An Integrated Wind-Water Desalination Demonstration Plant for an Inland Municipality

Final Report

City of Seminole
An Integrated Wind-Water Desalination Demonstration Plant for an Inland Municipality
TWDB Contract No. 0804830832
Comments from TWDB Staff

Figure 1. Integrated wind-RO layout for an inland municipality (Swift et al., 2009)

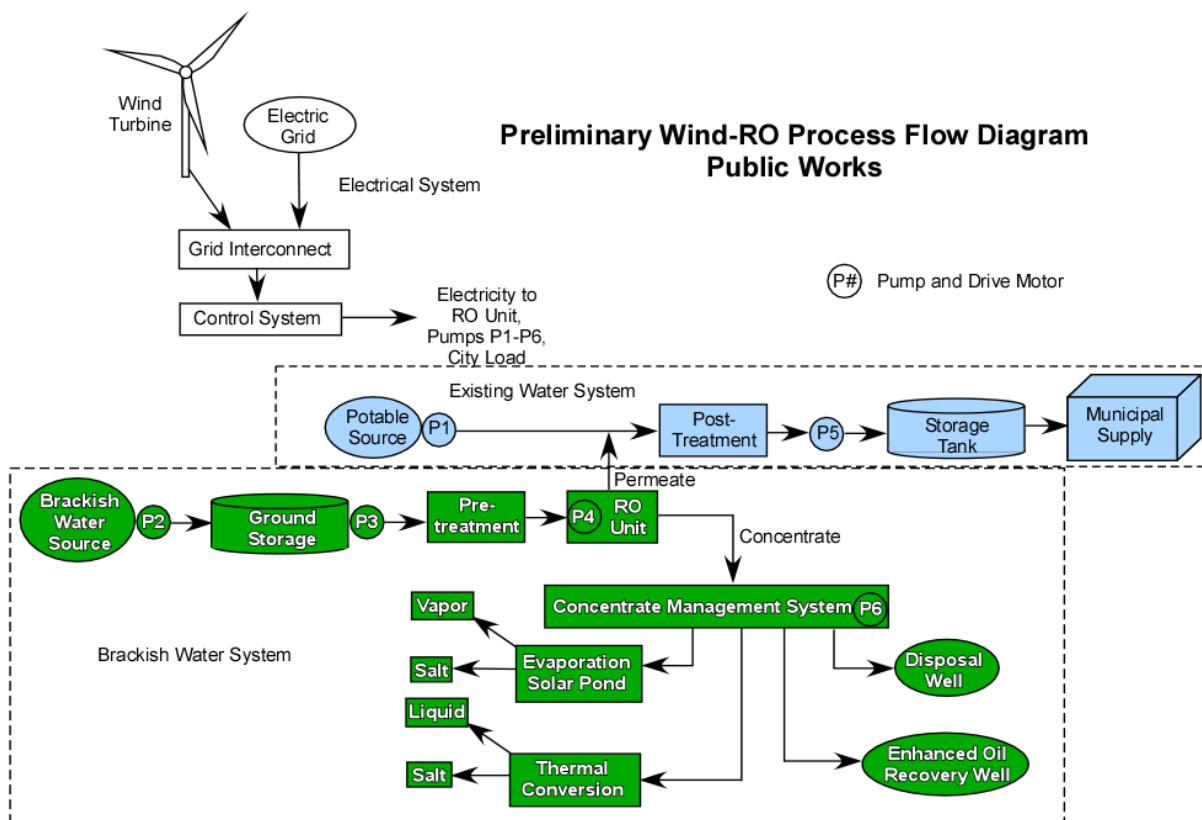
Page 7, Figure 1: Please consider creating a process flow diagram for this project.

A figure was added as the new Figure 10, and other figure numbers were updated.

Figure 12. Depth to water and TDS from Aqua Troll for November 3 to December 15, 2012

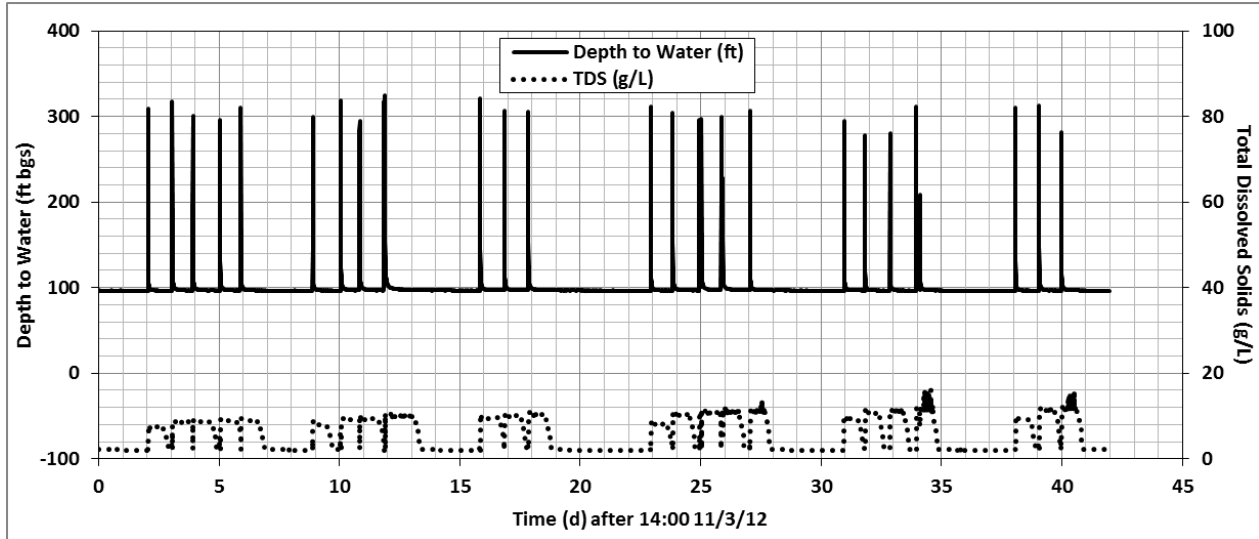
Page 20, Figure 12: Please consider reporting TDS in milligrams per liter instead of gallons per liter.

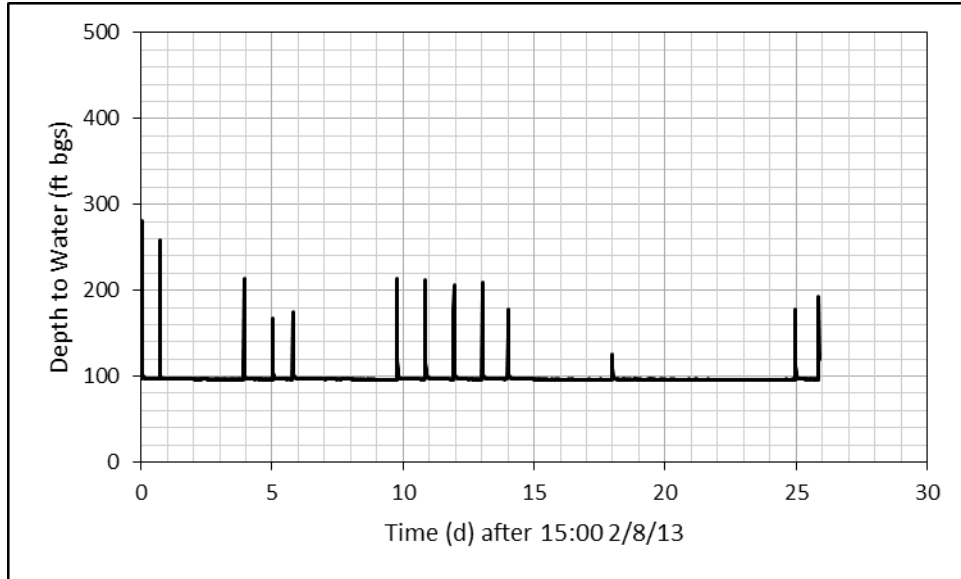
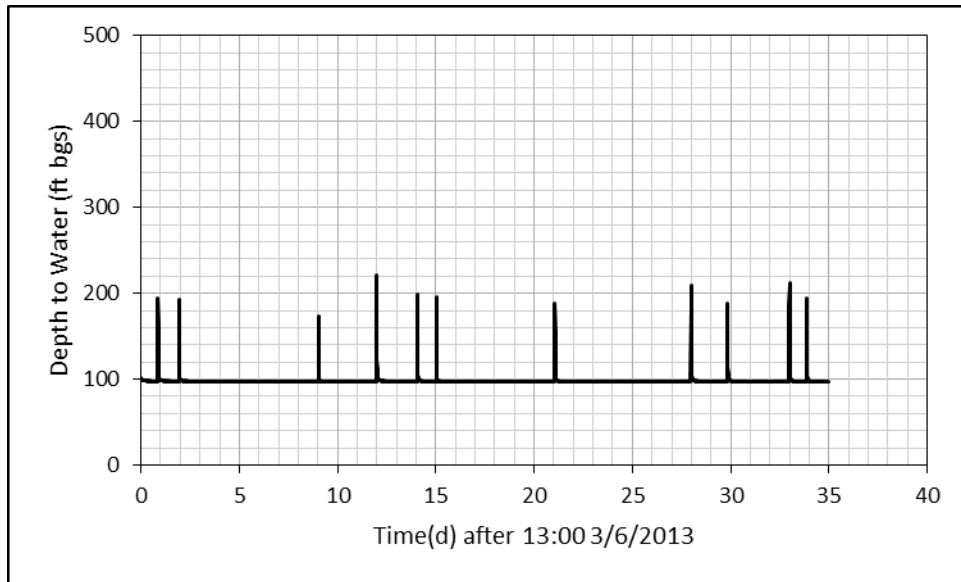
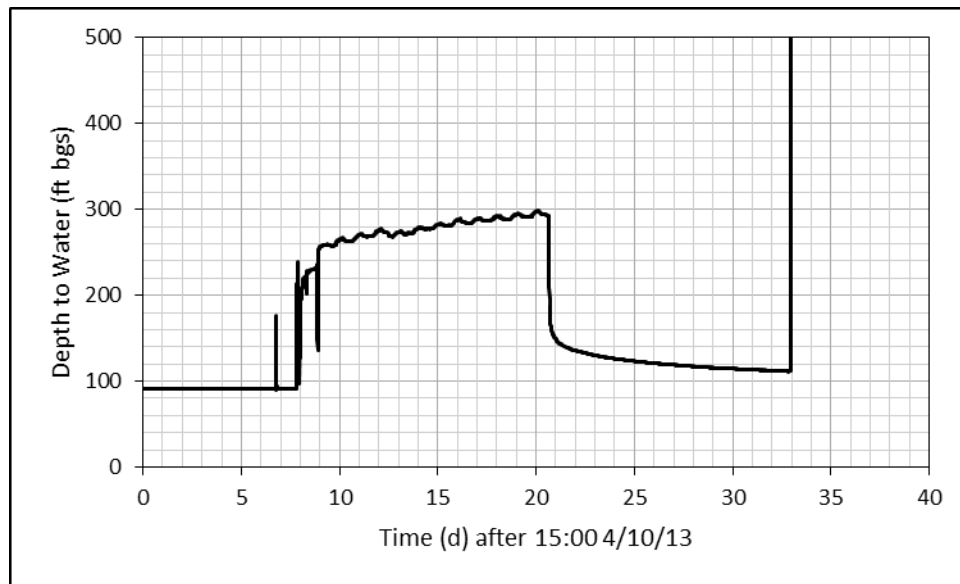
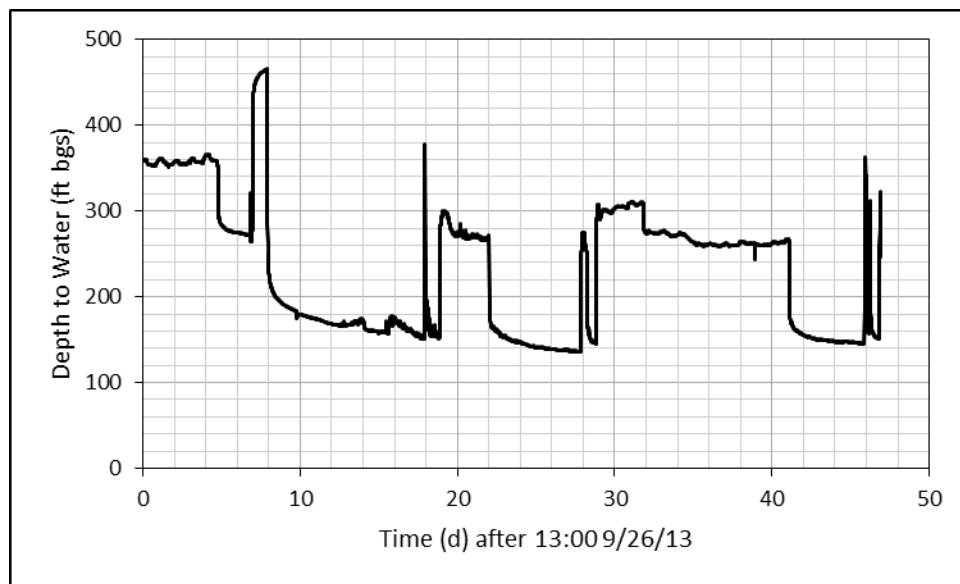
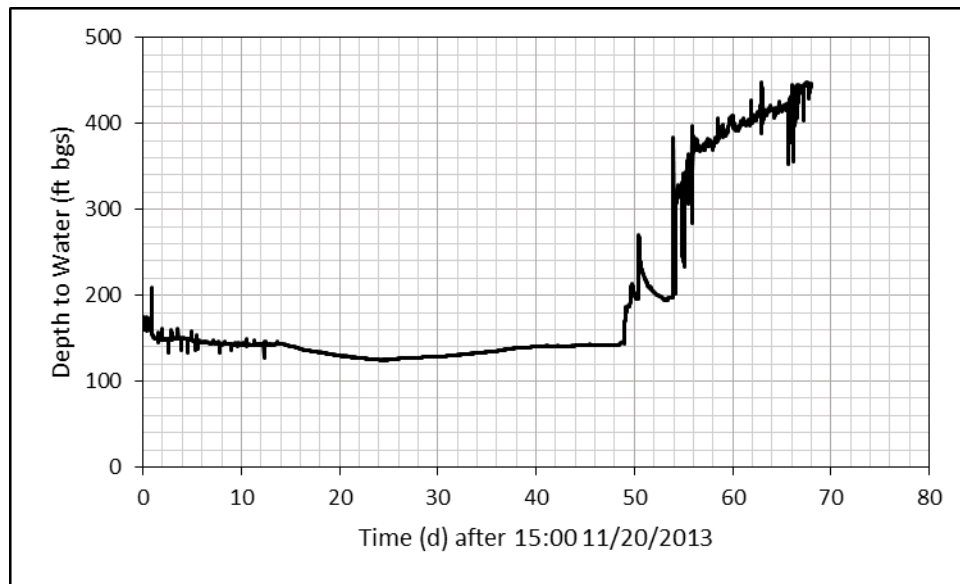
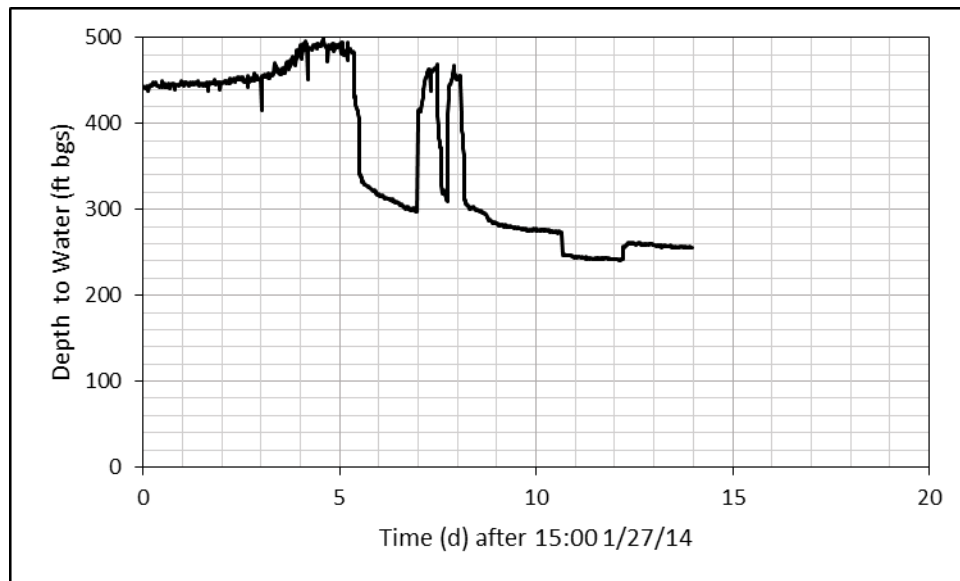
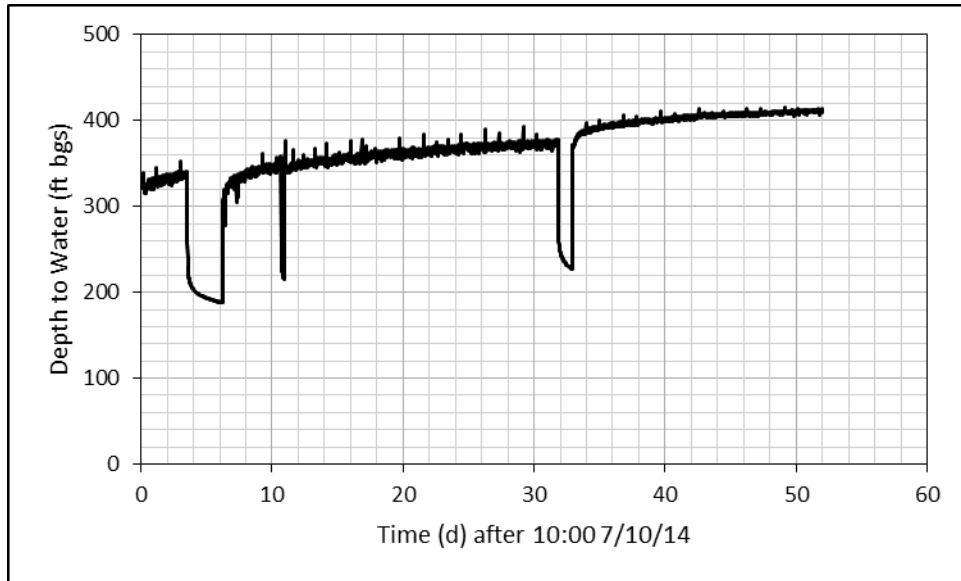
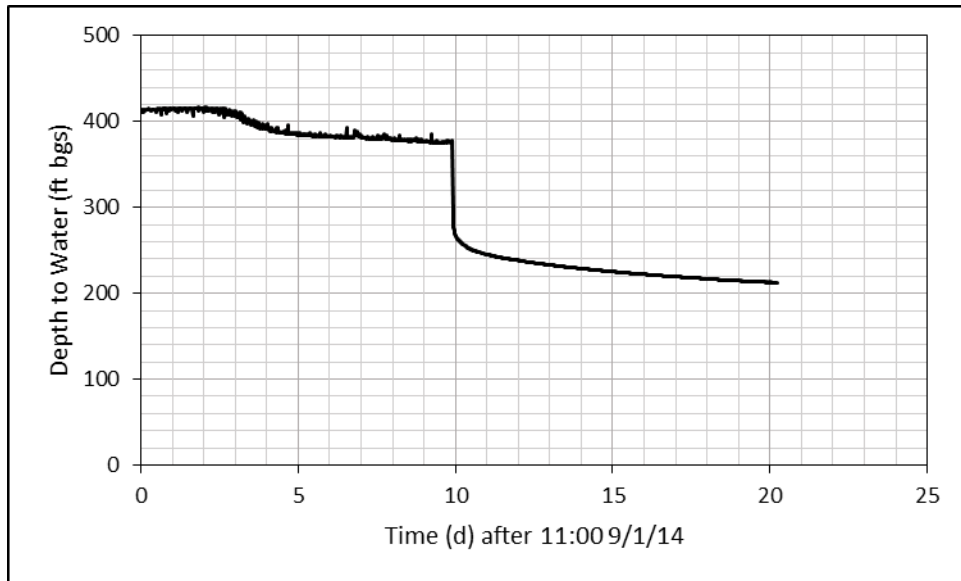
Pages 22-25, Figures 13-20: Please add “below ground surface” after “ft” in the vertical axis label.

Figure 22. Comparison of permeate, total feed, concentrate, and concentrate recycle flow rates

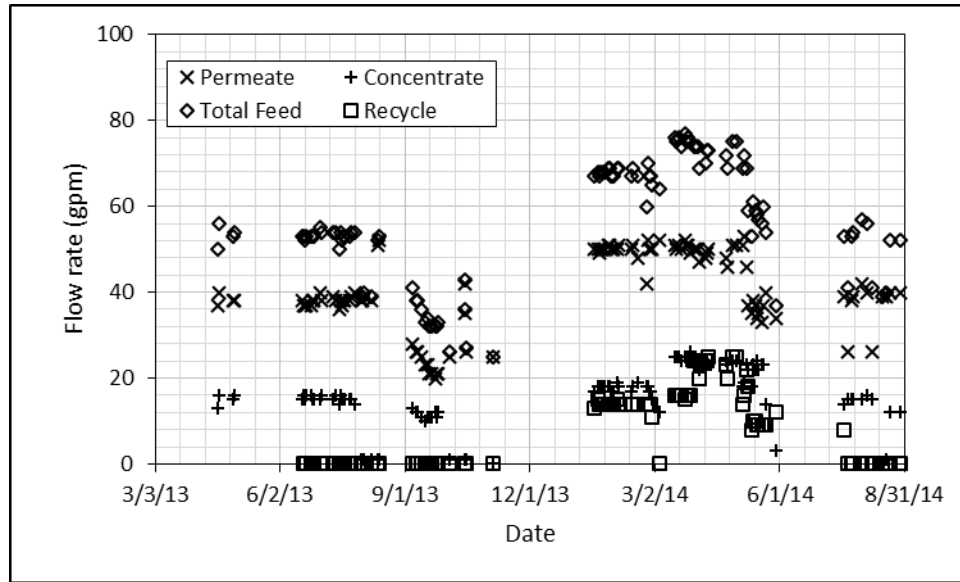
Page 29, Figure 21: Please consider using symbols to differentiate among more than two parameters. Using different colors for the parameters is difficult to see in black and white print.’

Figure 24. Comparison of permeate TDS from RO system sensor and Myron-L meter

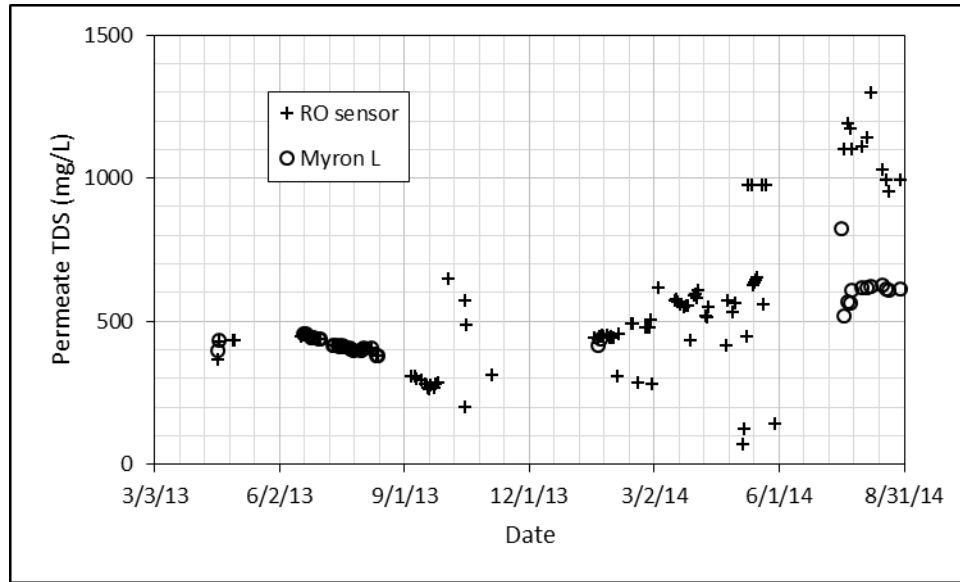
Page 30, Figure 23: Please consider changing the colors between the two parameters.

Figure 25. Comparison of TDS levels in the permeate from the three membrane vessels

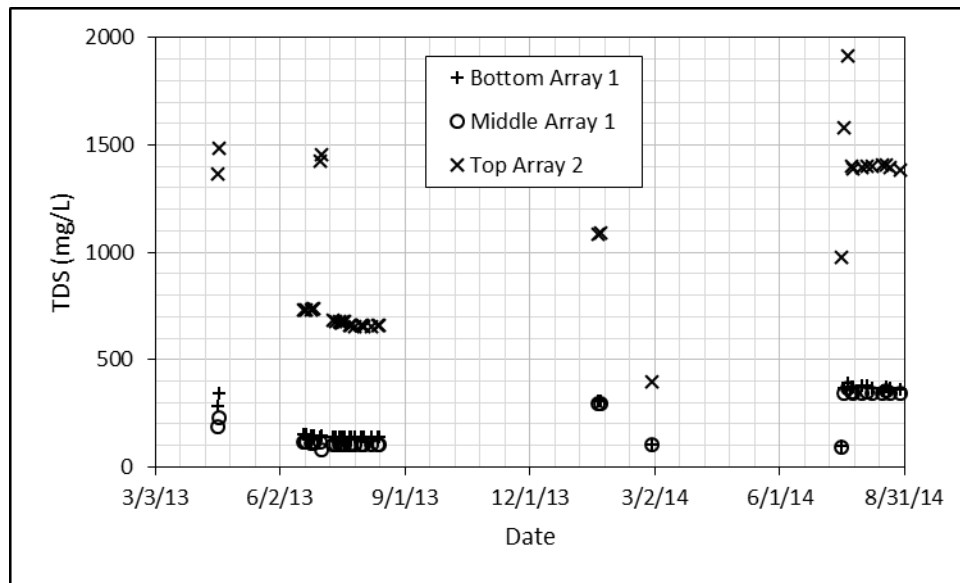
Page 30, Figure 24: Please consider using symbols to differentiate among more than two parameters. Using different colors for the parameters is difficult to see in black and white print.

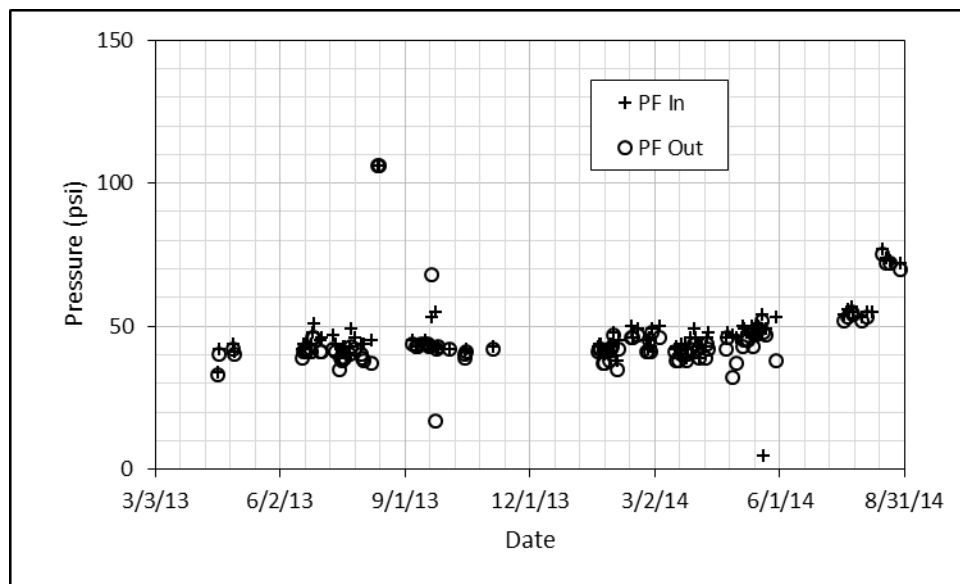
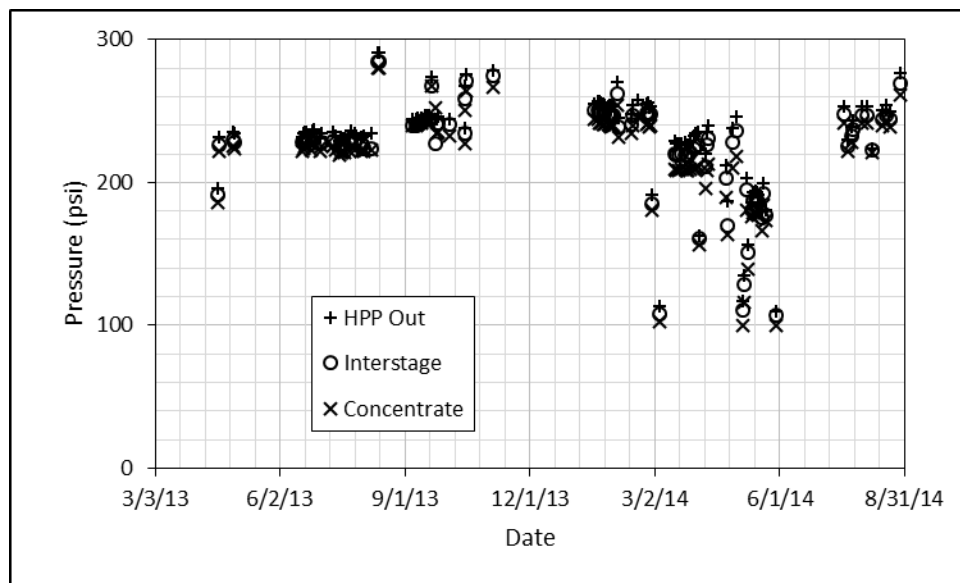
Page 31, Figure 25-26: Please consider using symbols to differentiate among more than two parameters. Using different colors for the parameters is difficult to see in black and white print.

Figure 28. Comparison of feed and permeate pH levels

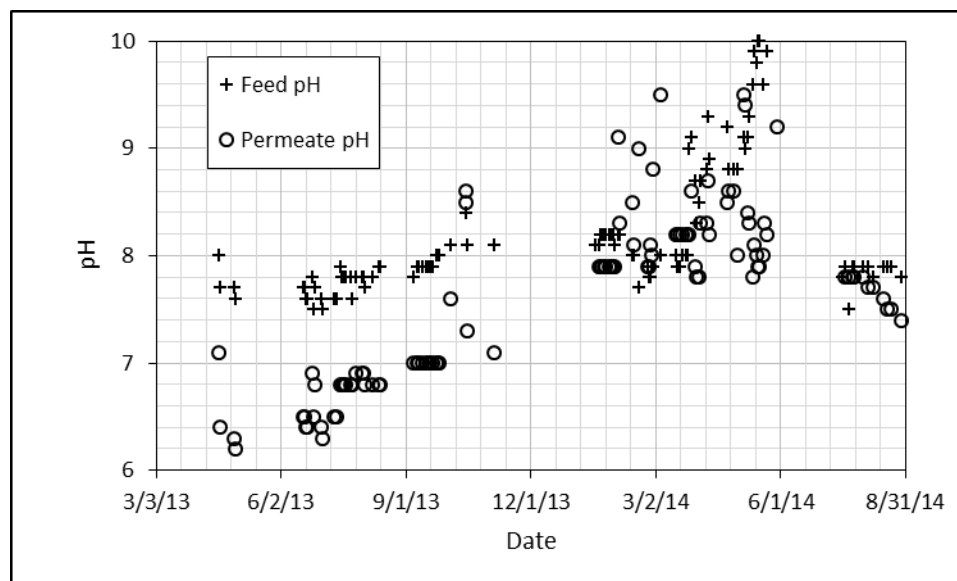
Page 32, Figure 27: Please consider using symbols to differentiate among more than two parameters. Using different colors for the parameters is difficult to see in black and white print.
